Work Order ID: 105357
Parent Item: D3303-041
Parent Item Name: Head Rest

DESIGN <i>PH</i>	DRAWN BY <i>B</i>	DART AEROSPACE LTD HAWKESBURY, ONTARIO, CANADA	
CHECKED <i>PH</i>	APPROVED <i>PH</i>	DRAWING NO. D3303	REV. B SHEET 1 OF 4
DATE 06.08.17		TITLE HEAD REST	SCALE 1:3
REV A	DATE 04.08.18	DESCRIPTION NEW ISSUE	
B	06.08.17	UPDATED FLAT PATTERN TO FORM PART IN ONE OPERATION USING OFFSET DIE

D3303	HEAD REST	ENGINEERING ORDER		D3303-B-1	SHEET 1 OF 1	NIS
DRAWN	AJS	CHECKED	MFG. APPR.	APPROVED	DE APPR.	
DATE	08.10.15	DATE	08/10/16	DATE	08/10/16	DATE

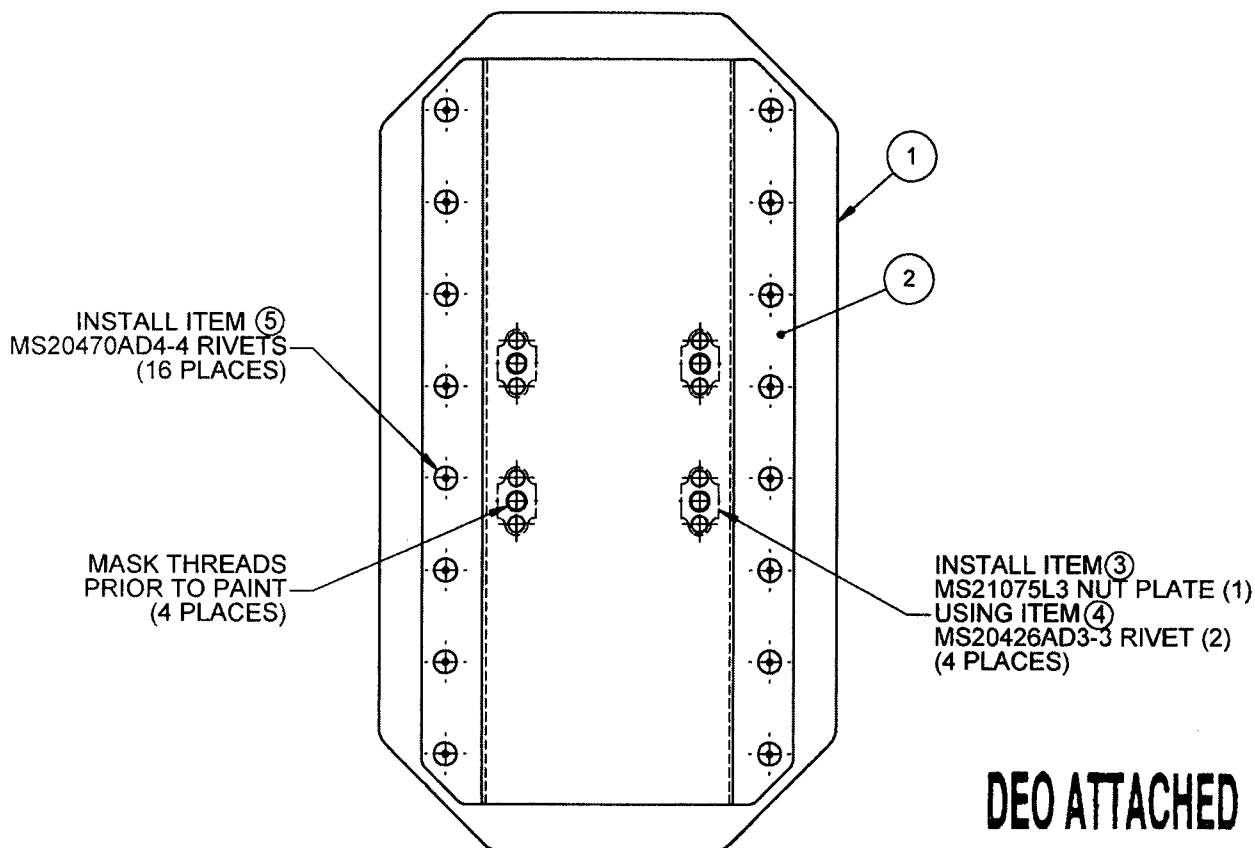
SHEET 1 ADD 1300L ADHESIVE BY 3M TO NOTE 1 AS FOLLOWS:

WAS:

- 1) BOND D3305-1 FOAM TO D3303-043 BRACKET ASSEMBLY USING 3M 1300 ADHESIVE (0.002" TO 0.010" THICK) IN ACCORDANCE WITH MANUFACTURER'S INSTRUCTIONS

IS:

- 1) BOND D3305-1 FOAM TO D3303-043 BRACKET ASSEMBLY USING 3M 1300 OR 1300L ADHESIVE (0.002" TO 0.010" THICK) IN ACCORDANCE WITH MANUFACTURER'S INSTRUCTIONS
